# Supporting Documentation

## Thelwall All Saints – Car park

**SCHEDULE OF WORKS OR PROPOSALS**

Resurfacing and marking of the Church Car Park.

drawing no. 2101/4  
03/08/2021

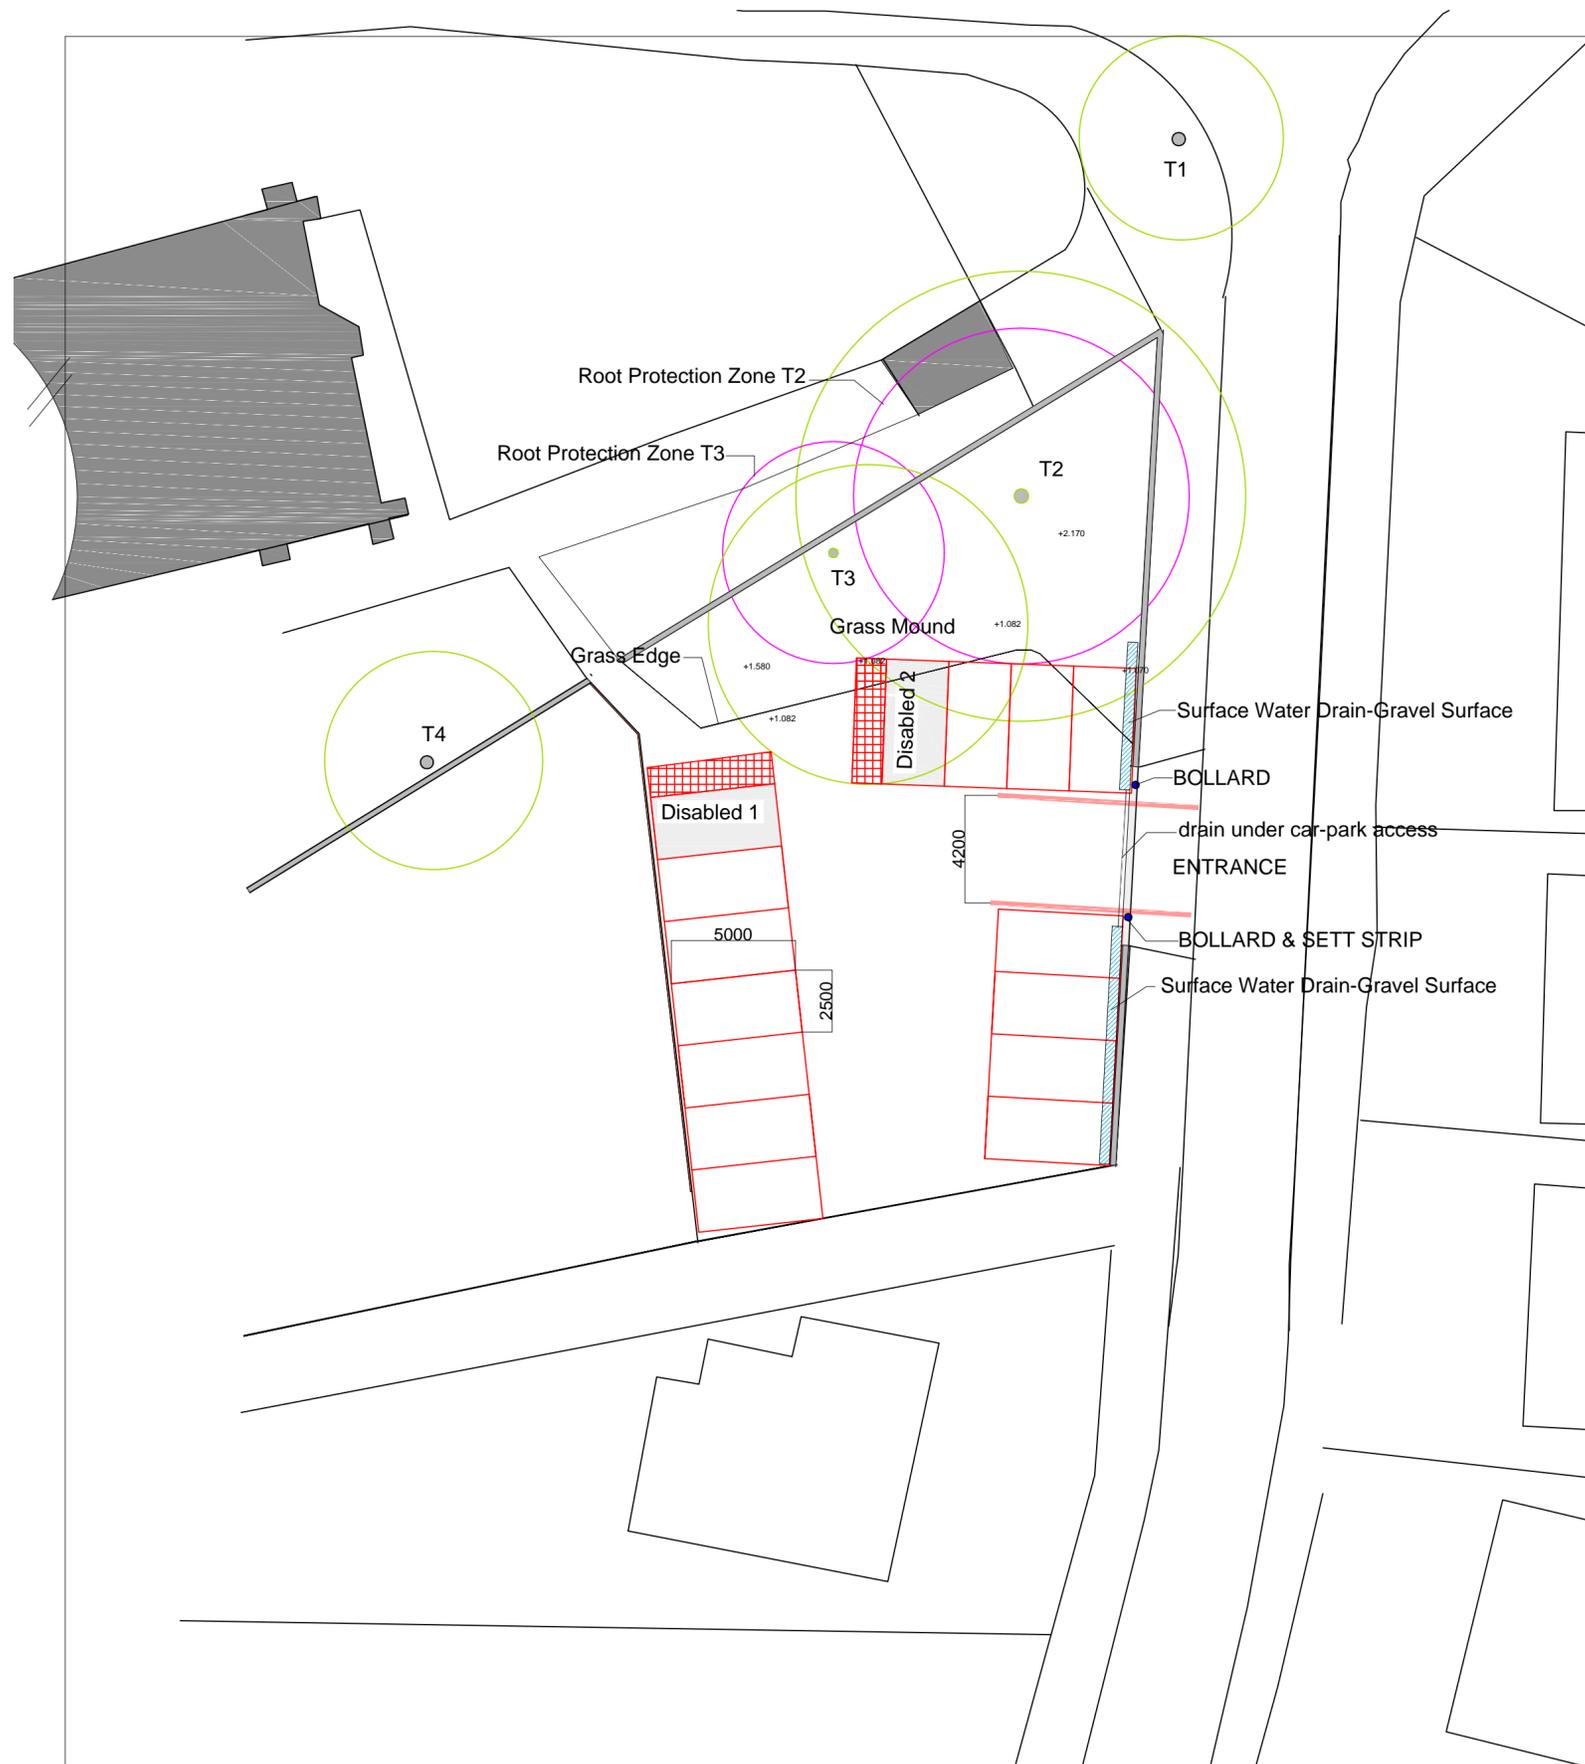
<p><b>02/03/2021</b></p> <p>To: Mike Horne,  Michael Vinsun</p>	<p>Just need to clear with the church treasurer to create a budget but fine with me. For a. could you indicate spot levels on the drawing and a surface water attenuation sump/grid at the entrance. Also to keep the church architect happy I suggest beyond the concrete edging you</p>

<p><b>12/04/2022</b></p> <p>To: Julie French From: Caroline Hilton</p>	<p>Further to our telephone conversation this morning, just to clarify, the proposals were last considered by the DAC at its meeting of 25 June 2021, and the Committee had offered the following feedback. I understand from our conversation that that the proposal no longer includes the removal of trees. It would be helpful if you could also confirm this.</p> <ul style="list-style-type: none"> <li>a. <i>It was agreeable to the proposed resurfacing</i></li> <li>b. <i>However, the removal of the trees in order to create parking spaces creates conflict with the Church of England’s green responsibilities and therefore needs firm justification</i></li> <li>c. <i>As the church is in Thelwall Village Conservation Area the parish should check with the local authority as to whether the trees are</i></li> </ul>

<p><i>protected. There may be some resistance as trees may be viewed as an important part of the setting</i></p> <p><i>d. It noted that one of the trees is distorted and the parish should seek the advice of an arboriculturalist as that may strengthen the argument for the felling of that tree</i></p> <p><i>e. The Committee appreciated the parish wish to create more space in the car park as it understood manoeuvrability can be difficult due to the shape of the carpark.</i></p> <p><i>f. It was pleased to note that the parish had advised it would replace the felled trees. It suggested the parish may wish to consider an alternative species to red oak as the leaves were particularly known to block gutters</i></p> <p><i>g. It noted that apart from the disabled spaces there are no parking spaces marked out, however it suggested the parish may wish to consider marking out parking bays as it disciplines people to park more economically and considerately</i></p> <p><i>h. The Committee suggested that the parish may wish to consider moving the car park entrance slightly northwards (but not too far as it is close to a junction) as a way of creating more spaces whilst saving the trees and keeping the bank</i></p> <p>I have added this proposal to the agenda of the forthcoming DAC Standing Committee on 29 April 2022.</p>

<p><b>21/04/2022</b></p> <p>To: Caroline Hilton From: Julie French</p>	<p>Further to our telephone conversation, I would like to clarify that the proposal to remove the trees on the banking is no longer an issue as having had a tree survey carried out we have found that they are safe at the moment.</p> <p>We are proposing to have two disabled parking spaces and are not thinking of moving the car park entrance.</p>
<p><b>22/04/2022</b></p> <p>To: Julie French From: Caroline Hilton</p>	<p>Thank you for this note, we'll include this when we discuss the carpark proposal at the Standing Committee next Friday.</p>
<p><b>05/05/2022</b></p> <p>To: Julie French From: Katy Purvis</p>	<p><b>DAC advice</b></p> <p>I am writing to let you know that at its meeting of 29 April 2022 the DAC Standing Committee considered the proposals for the carpark and wished to offer the following informal advice</p> <p>a. The Sub-Committee was content with the parish response, however it requested that the parish provide an updated plan of the proposed carpark showing its layout now the trees are to be retained.</p> <p>b. It noted the faculty application had been started on the Online Faculty System and looked forward to receiving the completed application</p>

From: Julie French	
<b>18/05/2022</b> To: Katy Purvis From: Julie French <b>With attachment</b>	Please find Base Layout plan as requested  <a href="#">9) Revised Layout Plan, drawing number 2101/4 of Michael Vinsun</a>
<b>23/05/2022</b> To: Katy Purvis From: Julie French <b>With attachment</b>	Please find Statement of significance for uploading  <a href="#">3) Statement of Significance</a>
<b>30/06/2022</b> To: Julie French From: Caroline Hilton	<p>I am writing to let you know that at its meeting of 24 June 2022 the DAC considered the faculty application and further details you provided regarding proposed works to the church car park and it resolved to recommend the scheme.</p> <p>The Committee also wished to offer the following informal advice:</p> <ol style="list-style-type: none"> <li>a. There was concern about whether it would be possible to safely manoeuvre in and out of some of the spaces, and that up to three of them may not be usable. It questioned whether the layout of the parking spaces conform with the parking guidelines. It suggested that before marking out the spaces the parish experiment with road cones to ensure the spaces are practically usable and conform with the official guidance</li> <li>b. It may be worth considering whether altering the angle of parking spaces to be vertical or herringbone pattern may be helpful</li> </ol> <p>This means I can raise the Notification of Advice which will allow you to proceed with the public notice period. I will send you an email letting you know once I have carried this out and with instructions of what to do next to progress the faculty application.</p> <p>If you have any queries please do let me know.</p>
